POSGCD Discussion of Comments to File on GMA 12 Proposed Desired Future Conditions

Presented To: POSGCD Board of Directors:

July 13, 2021

DFC Committee: Sensitivity of Number of Impacted Wells to POSGCD Carrizo Production

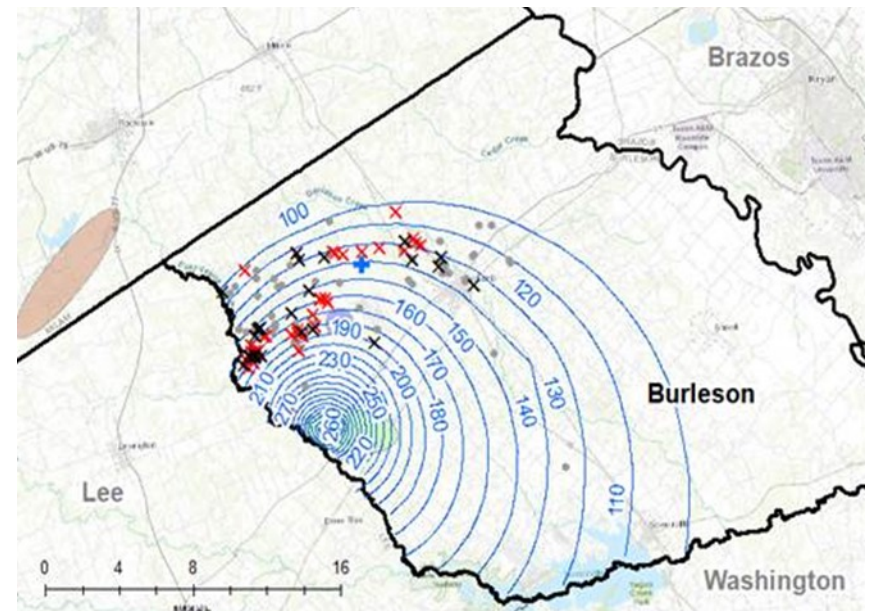
Impacts of Carrizo Pumping on Estimated Number of Impacted Wells

- DFC Committee 2020-2021
 - Evaluations show current DFCs for Carrizo are not possible
 - Threshold 2 for Rule 16.4 has been reached for Carrizo
 - Recommended to cap Carrizo pumping at 12,000 AFY
 - Based on achieving a balance between production & impacts
 - Consistent with POSGCD initial estimate of ~11,200 AFY in 1st Round of Joint Planning before GMA 12 reduction for compatibility
 - Proposed DFC for cap of 12,000 AFY is 145 ft
